Reference: Request for Amendment to Con Edison Solar Project PB approval of October 15, 2020 -
CMP Interconnection design change

Reference: Request for Amendment to Con Edison Solar Project PB approval of October 15, 2020 - Amended Plan Layout

Reference: Request for Amendment to Con Edison Solar Project PB approval of October 15, 2020

City of Gardiner March 2021 Amendment
Planning Board Review Application

OVERALL CONCEPTUAL LANDSCAPE PLAN

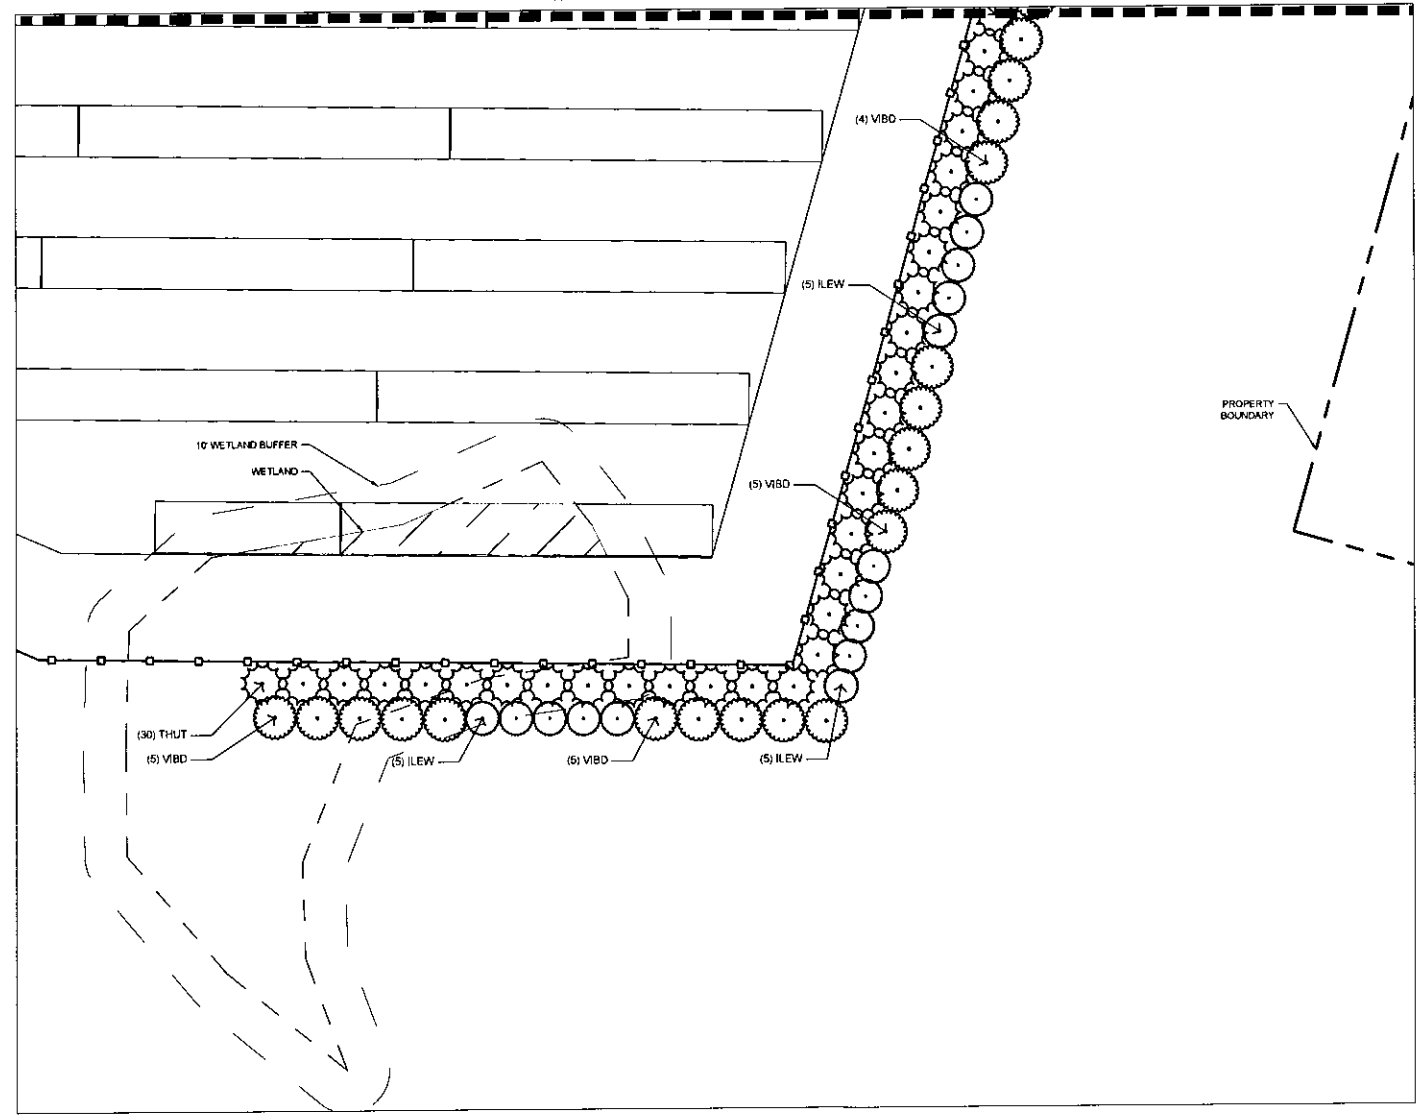
In addition to adjusting the layout as noted above, after consultation with the neighbors most visually affected we have developed an enhanced vegetative buffering plan (Figure 3) which we believe addresses the majority of concerns and comments we heard from the neighbors. The enhanced plan provides the following improvements and additions:

- Replacement of deciduous trees with evergreens, which will provide year round buffering of the solar farm for the neighbors;
- The addition of 86 Evergreen trees or approximately a 36% increase more than our original approved plan. The addition of the Evergreens will provide a superior and year-round buffer for our neighbors - without creating leaves that could blow into their yards for them to rake; and
- The addition of 296 shrubs or approximately a 65% increase more than our original approved plan. The addition of both quantity and variety of shrubs will provide a balanced buffer that will add depth, color, and undergrowth to the Evergreen trees.

SHEET TITLE
FIGURE 1

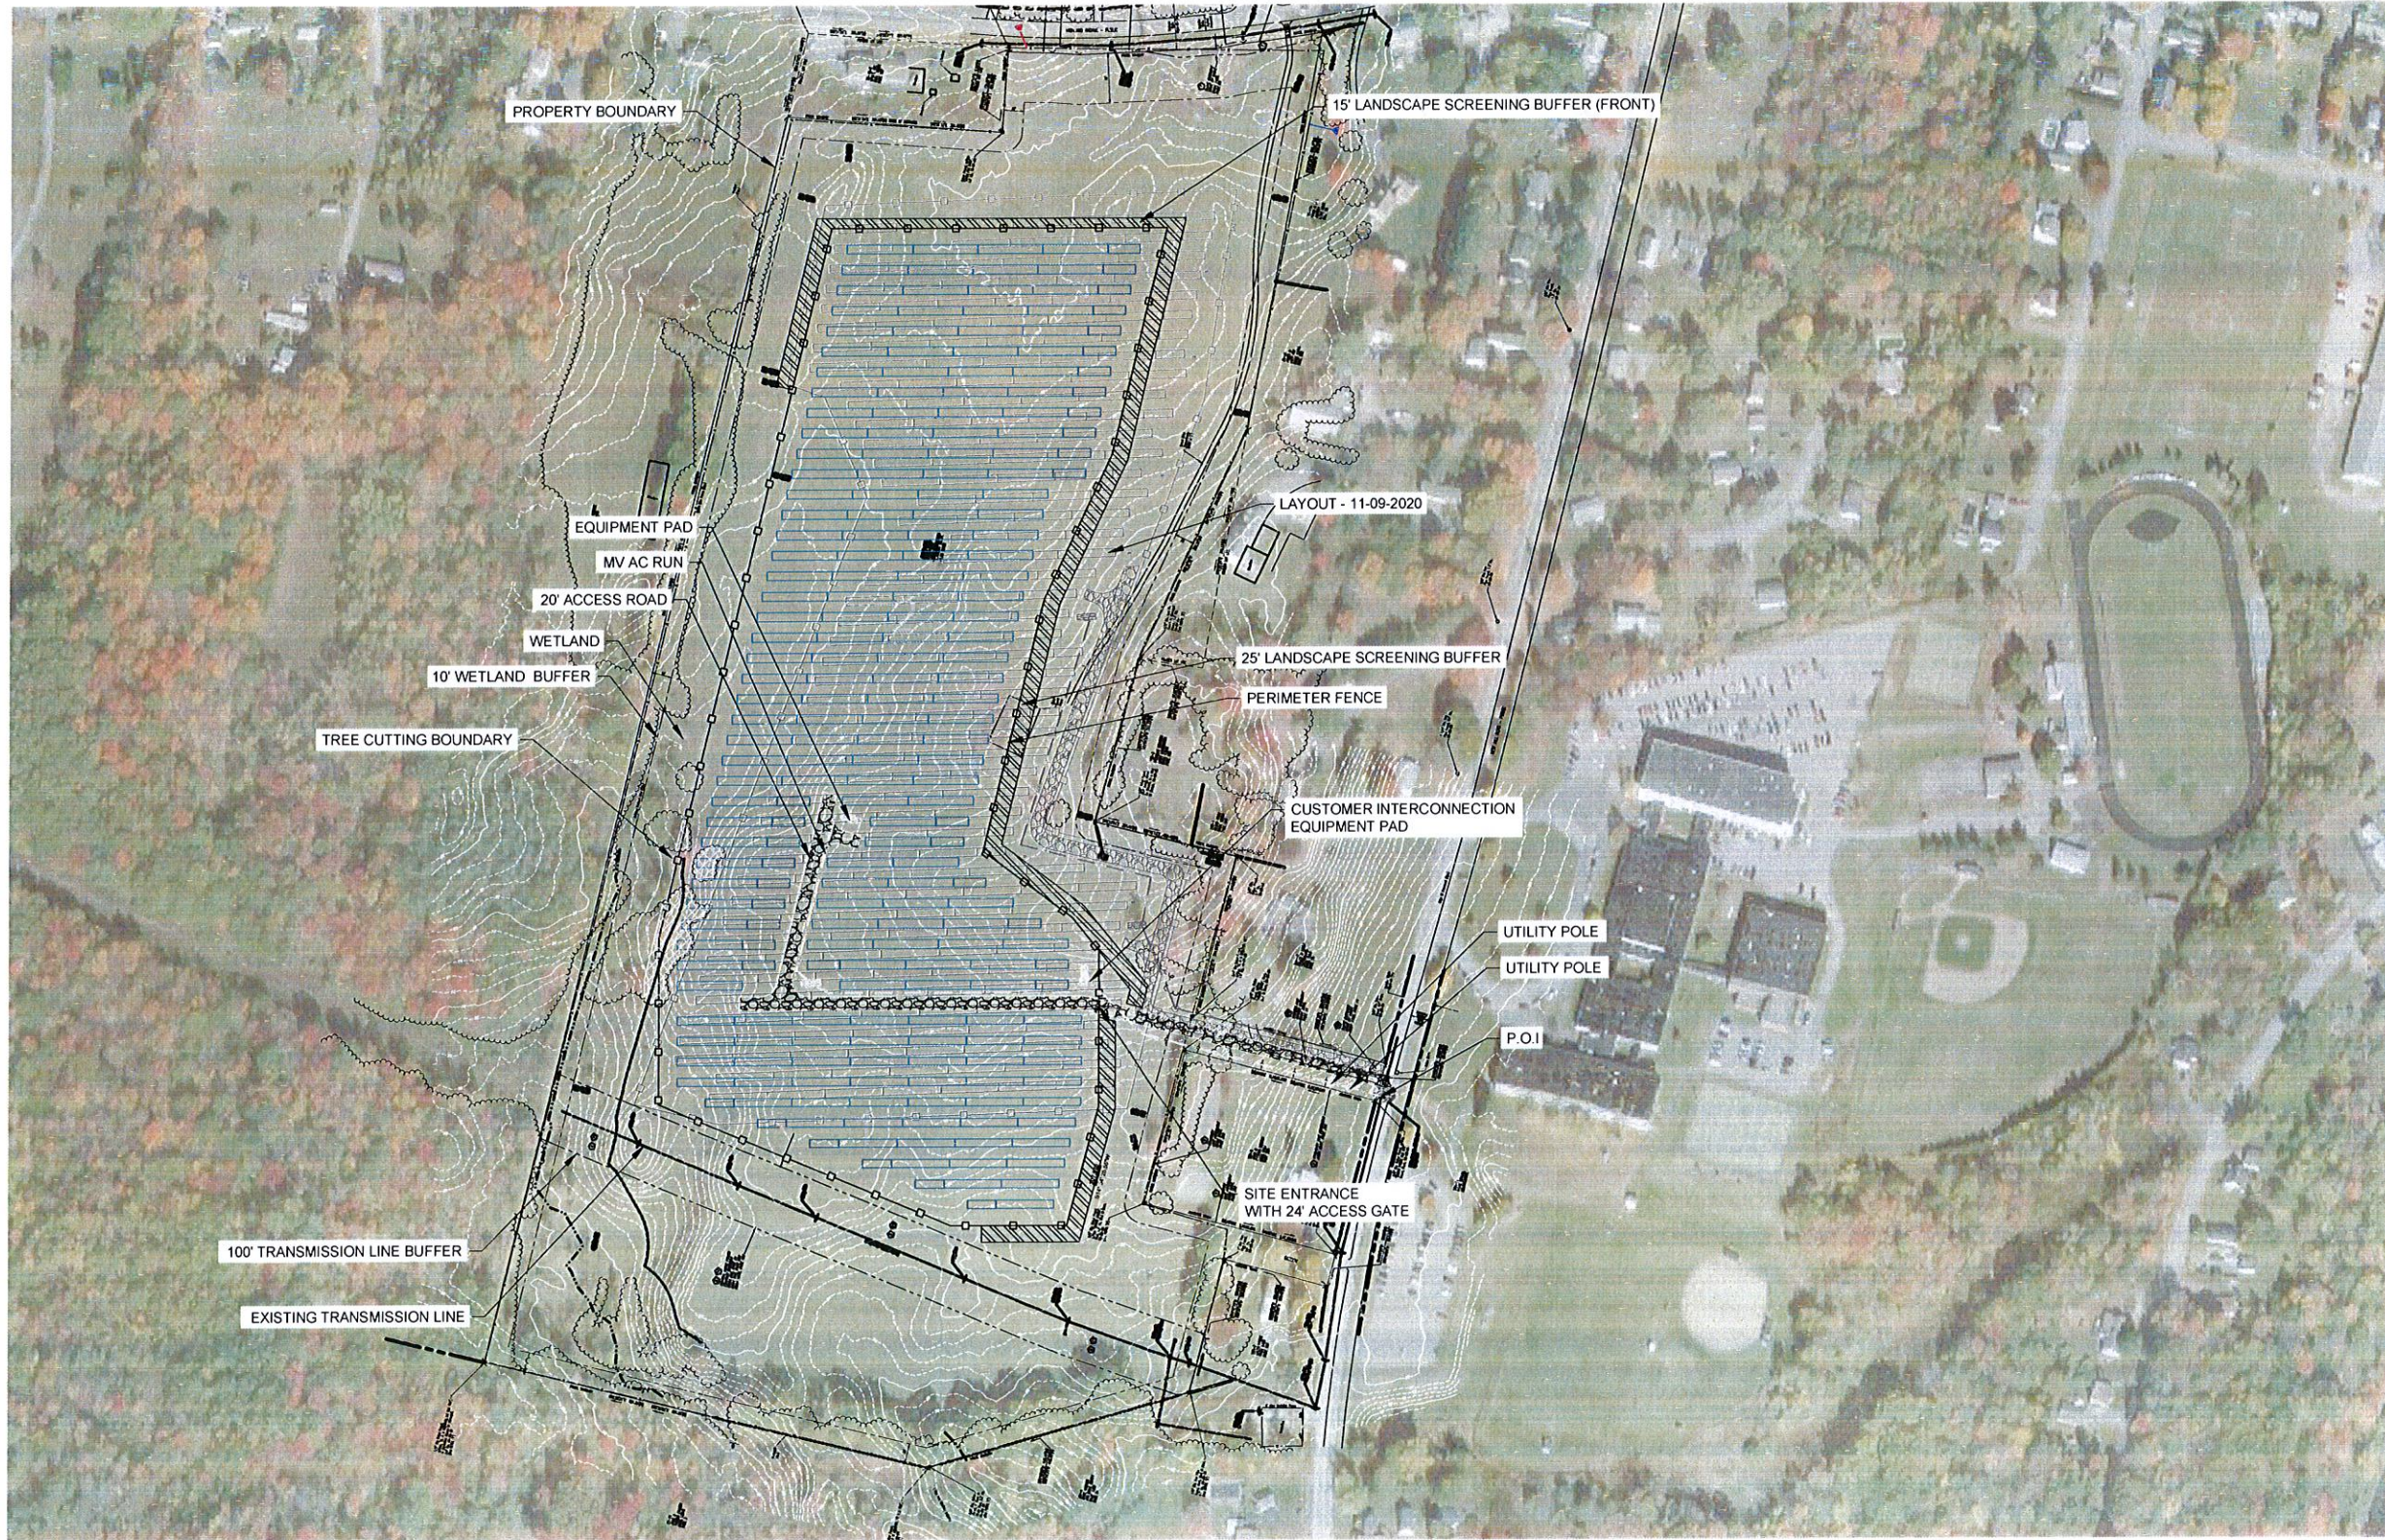
Con Edison Development is submitting revised Figure 1 and Figure 2, specifically to update the proposed interconnection arrangement between our proposed solar farm and the CMP Point of Interconnection (POI) on West Hill Road. This revision is based on the results of a teleconference with CMP to review the interconnection arrangement and to address our plan to connect to the CMP POI using undergrounding electrical lines to a single pole, as depicted on our previously submitted Amendment. During the CMP call it was conveyed to Con Edison Development that 2 poles are required to allow ample room to place CMP equipment on each.

Based on this call we have revised our Figures to reflect this change. Note that all lines from the solar farm to the first pole will remain underground as originally designed. No other changes to the Figures were made and remain compliant with applicable Gardiner performance standards.

Figure 1 – For comparison purposes, Figure 1 shows the original approved site layout in light gray and the proposed layout

- Shifting the layout west and south to gain a greater distance from the neighbors to the east and north;
- Relocating the solar farm's internal driveway from the eastern property boundary to the center of the site;
- Relocating the transformers from the eastern property boundary to the center of the site;and
- Placing the interconnection lines from the solar farm to the connection on West Hill Rd underground until they reaches a single riser pole and then tie into the existing CMP line.

SHEET TITLE
FIGURE 2

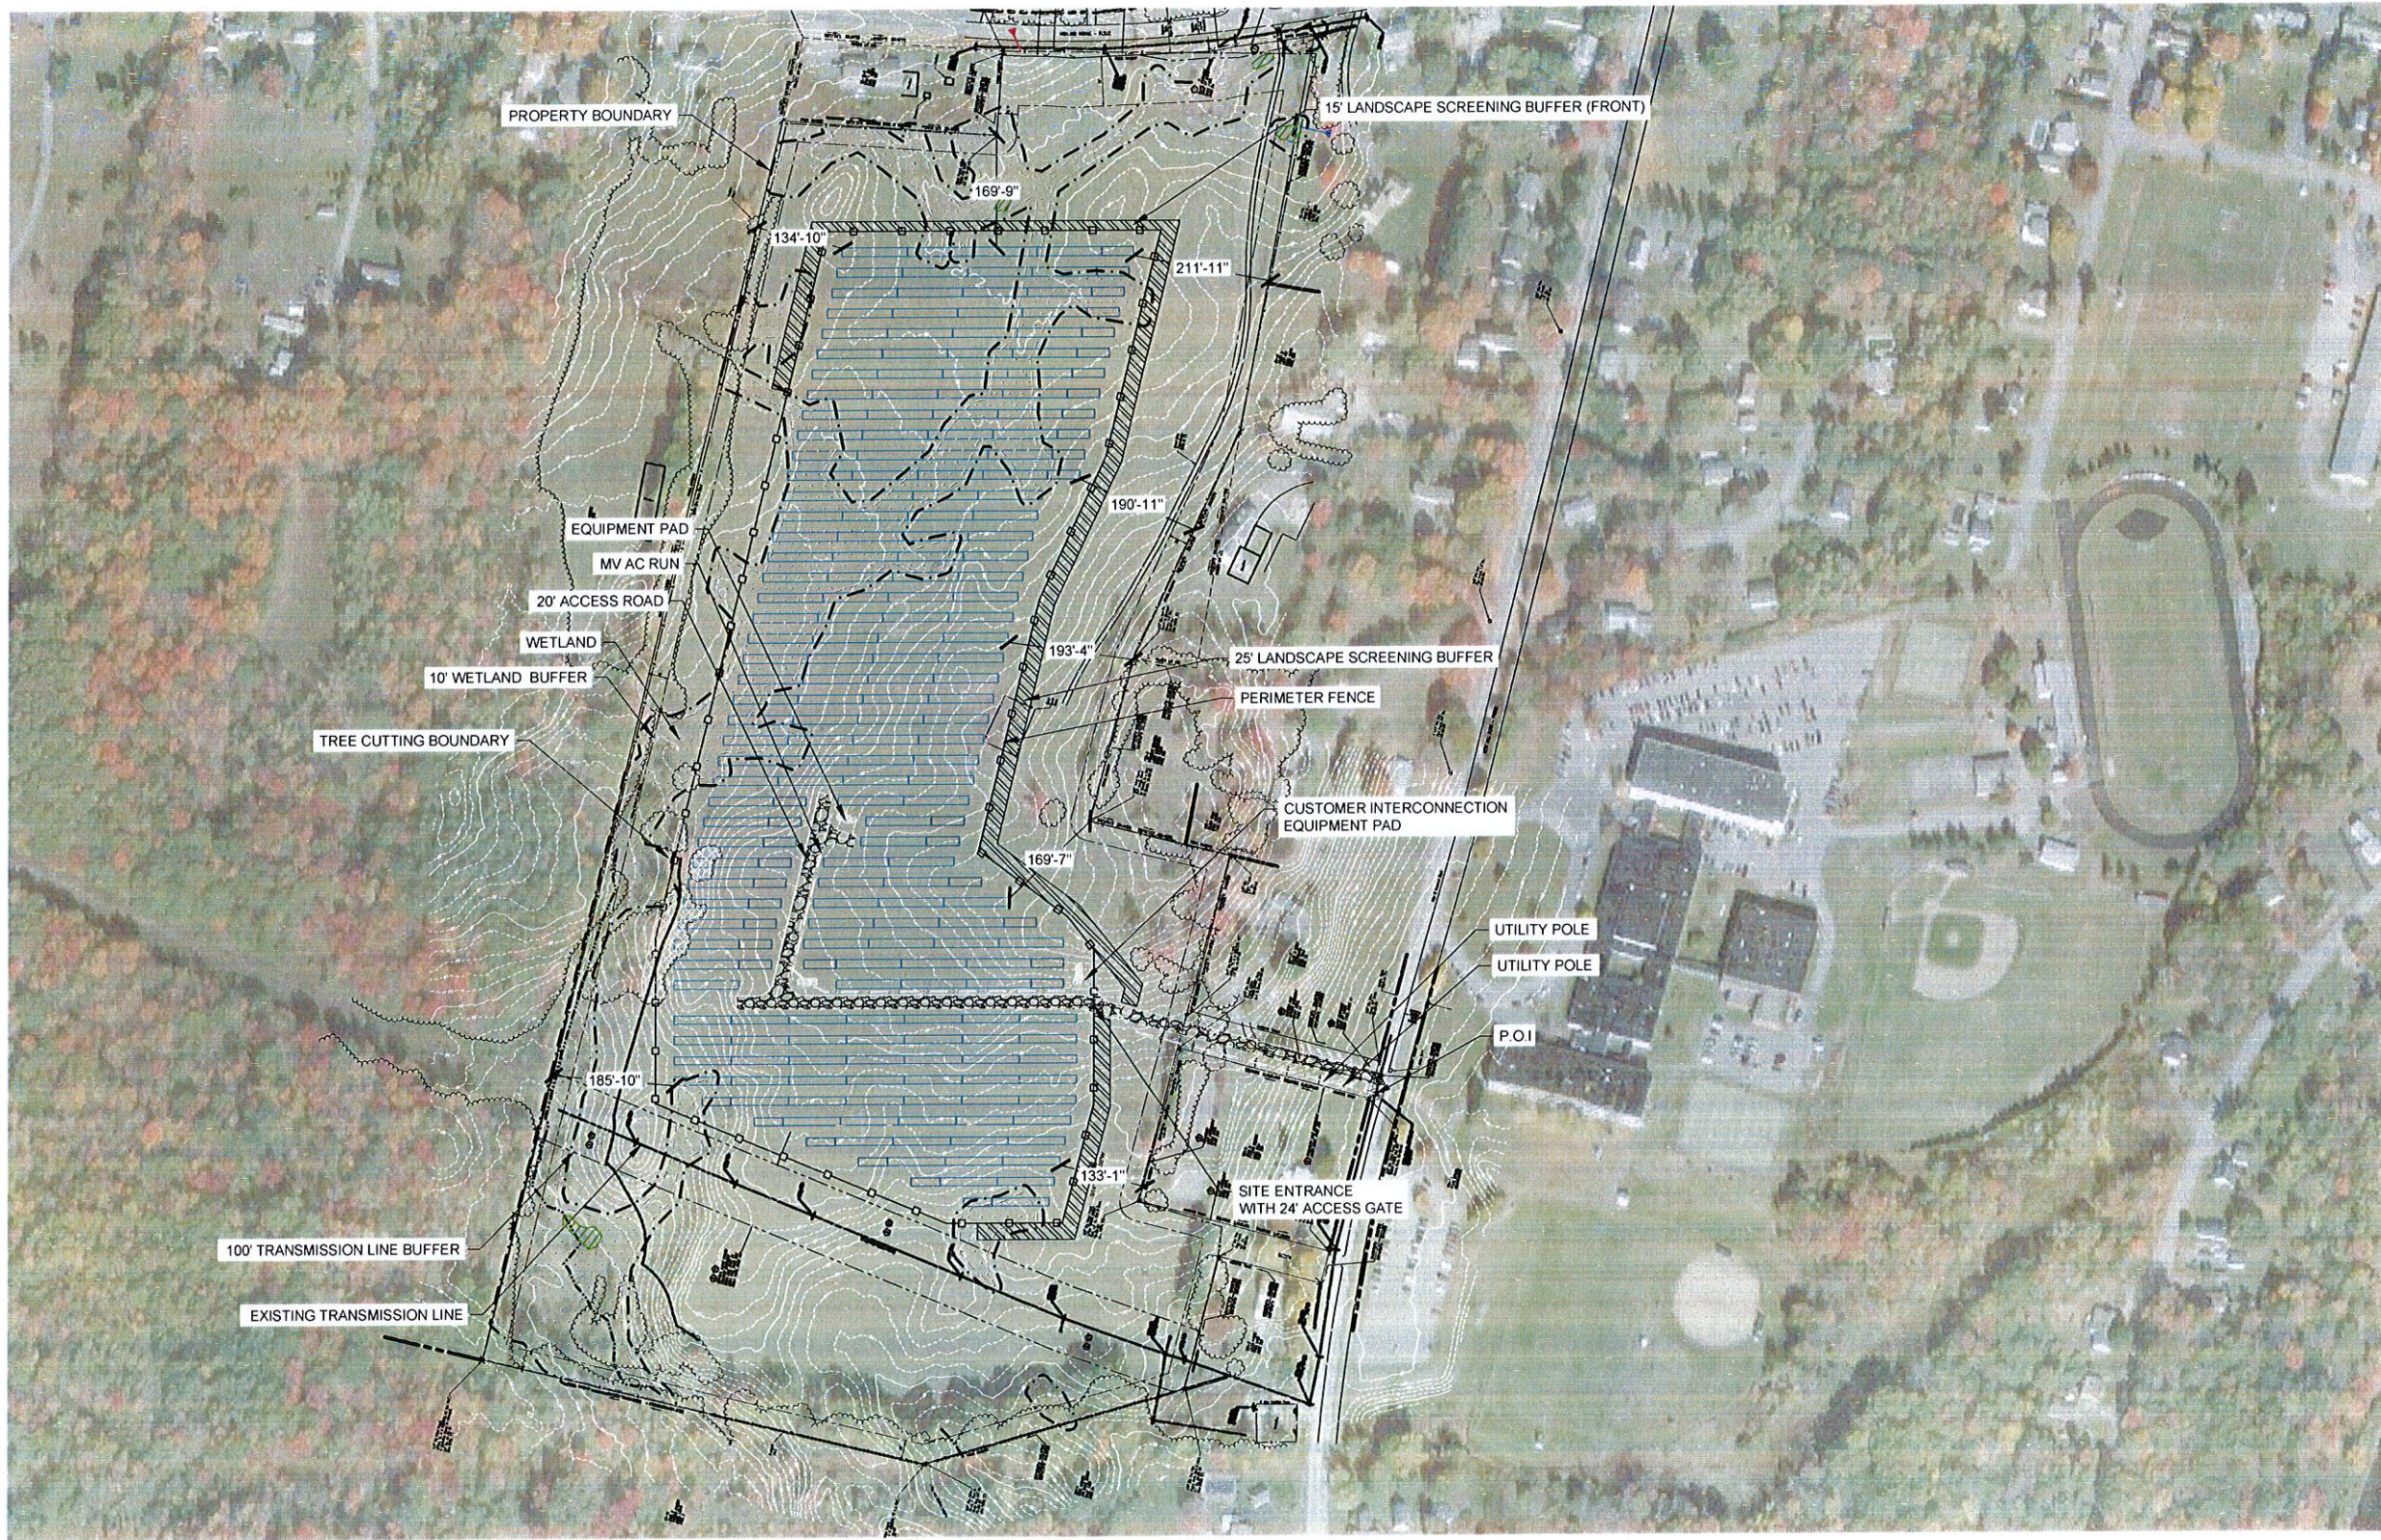
Figure 2 – Figure 2 shows just the proposed site layout that is the subject of this amendment.

Overall the amended site layout provides a significant increased buffering of the neighbors from the solar array by moving it further away from them, and moving the driveway and transformers to the center of the array.
